SUPPLEMENTAL INSTRUCTION

PROJ.: **Boys and Girls Club Prince of Wales**
PROJ. No.: **1716**
DATE: Dec 8, 2017
S.I. No. **S.I. - 001**

1.1 TITLE
Deletion of Electrical Switch and Meter Closet

IB-A001

DRAWING TITLE:
**GROUND FLOOR
PLAN**

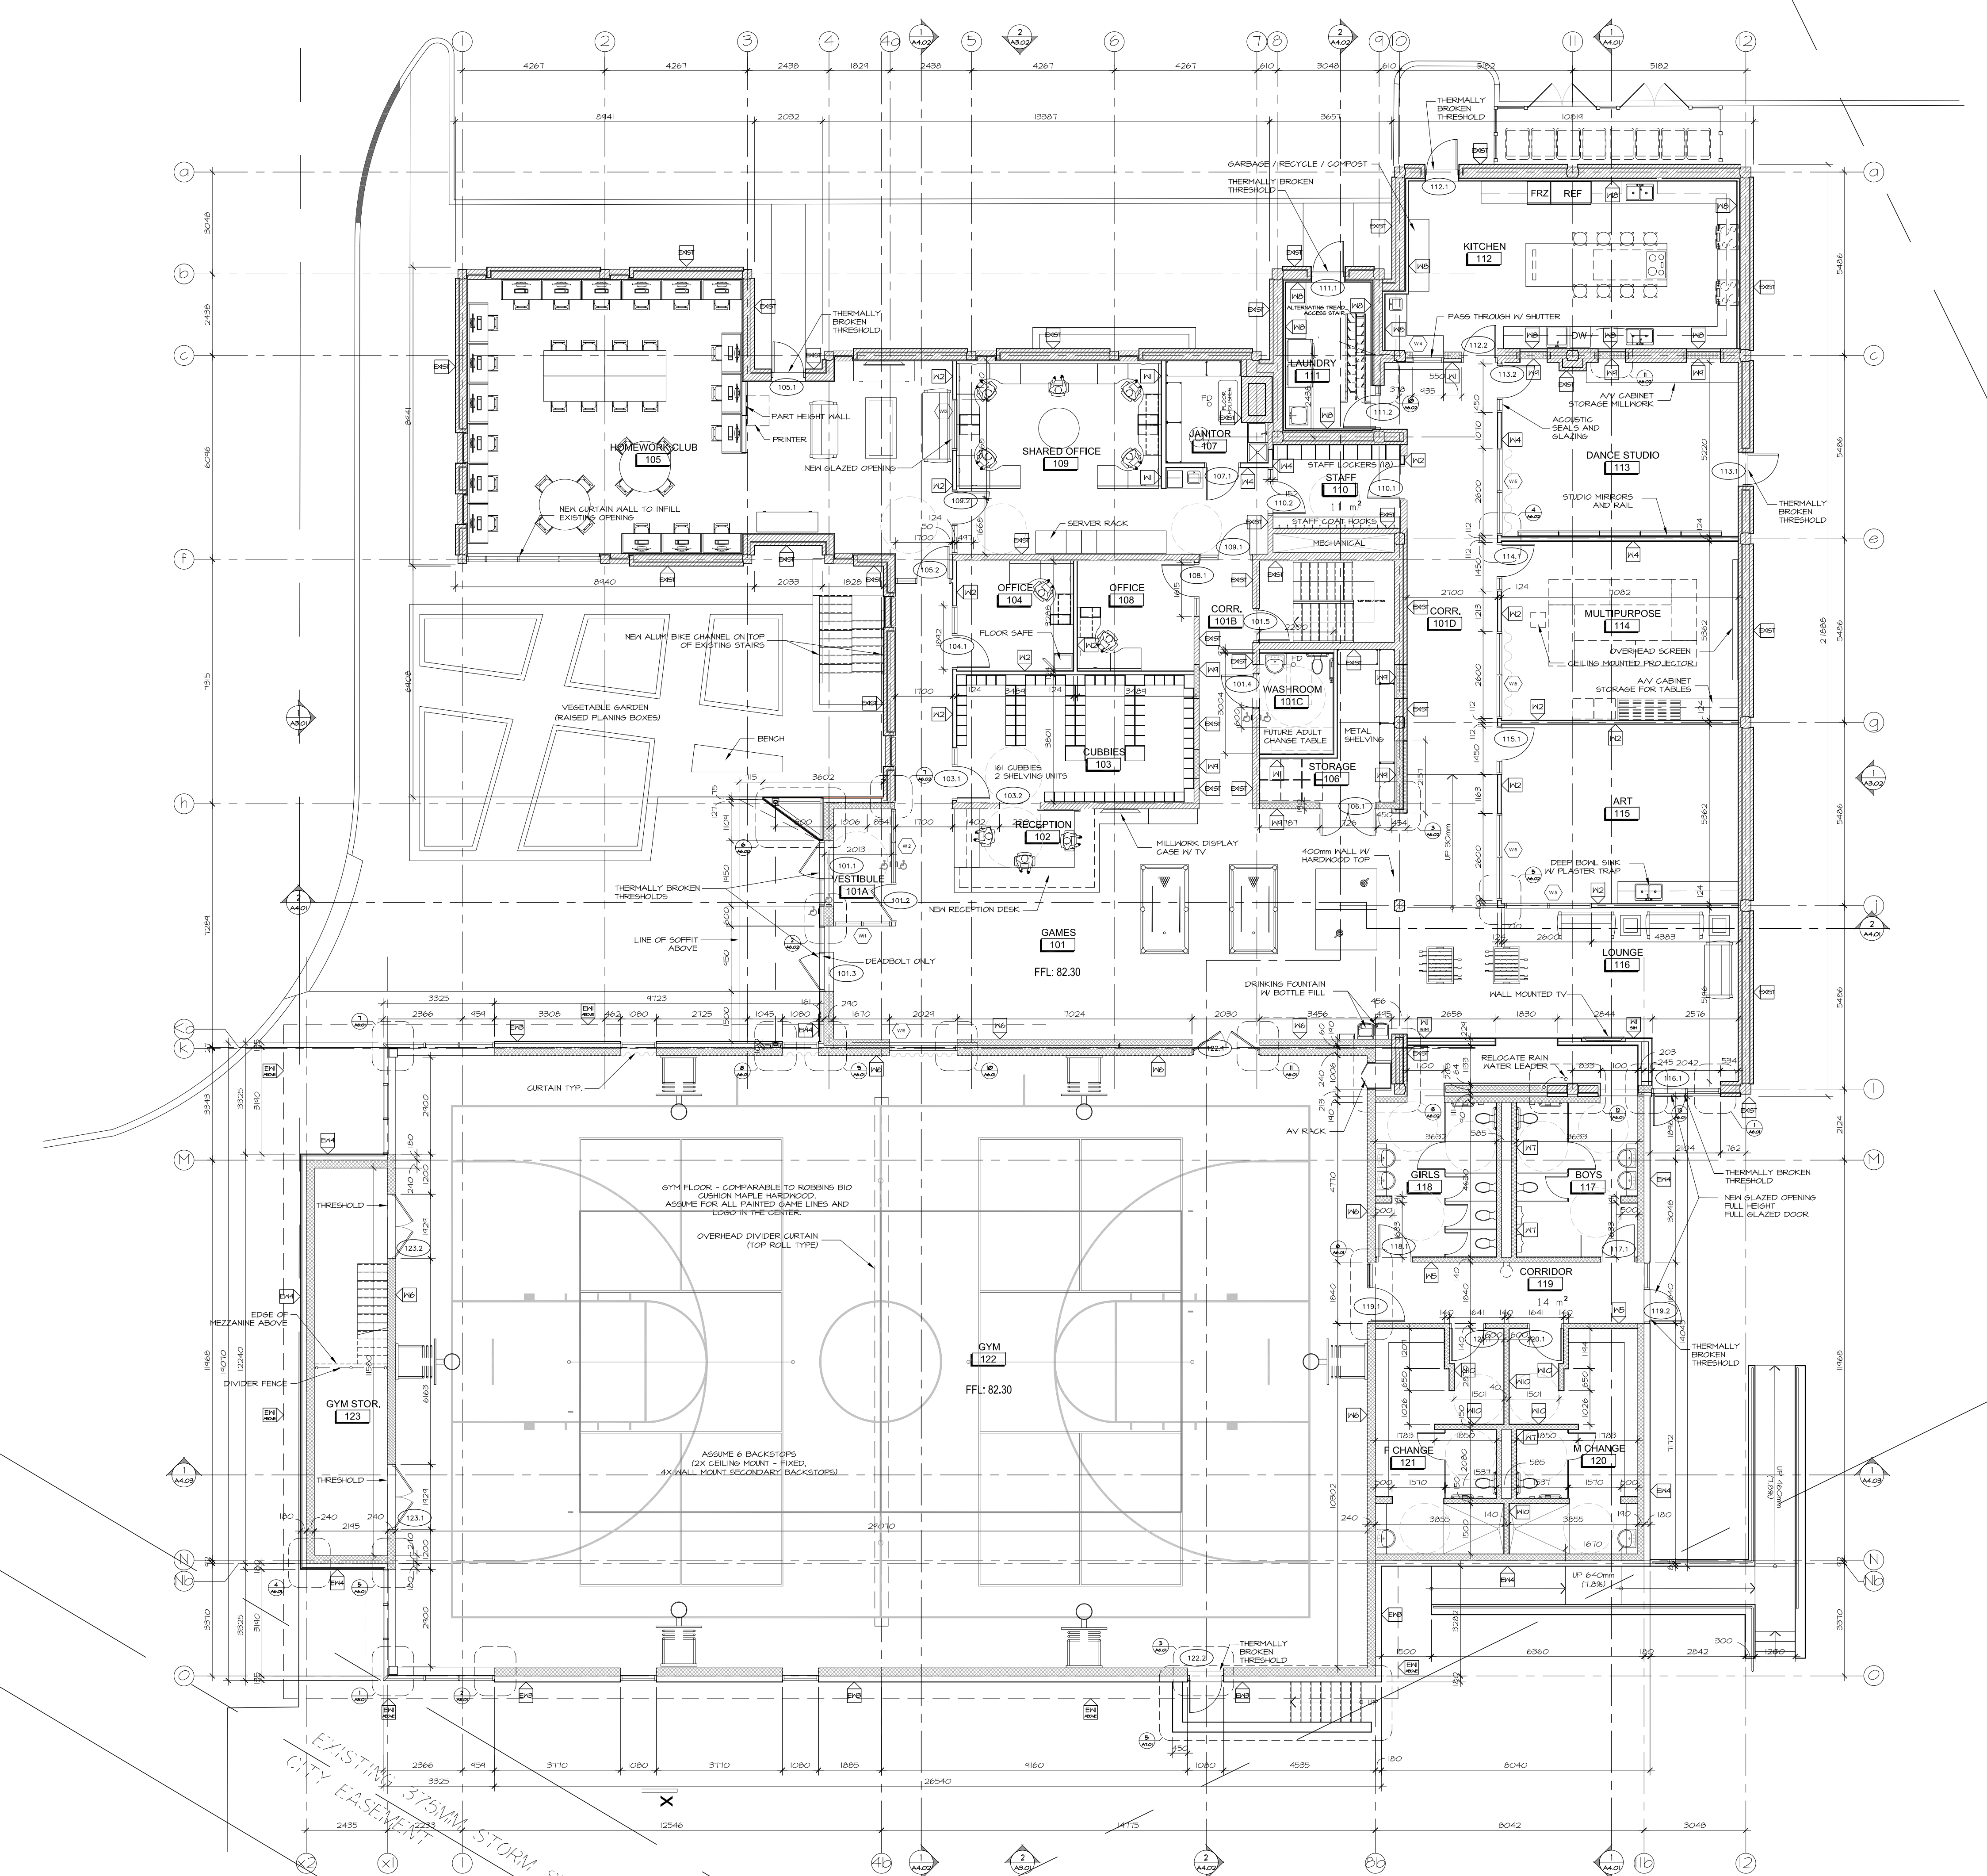
- .1 Attached is please find Hobin Architecture Inc's response to City of Ottawa permit comments.
- .2 Drawings A2.1 is re-issued showing deletion of Hydro switch closet near Gridlines L-12.

6. The location of the new disconnect for the main power feed is shown on the drawings beside door 116.1 at the intersection of Gridlines L-12. Has any consideration been made to locate the disconnect in the Electrical Room in the basement by running the feed underground? Please advise.

That is correct...

So that means that we no longer need that closet by 116.1, correct?

Hydro is indicating that having the meter in the electrical room (in basement) is OK.

Initial comment from Hydro Ottawa prior to site visit is that Hydro prefers the disconnect & meter in the electrical room.
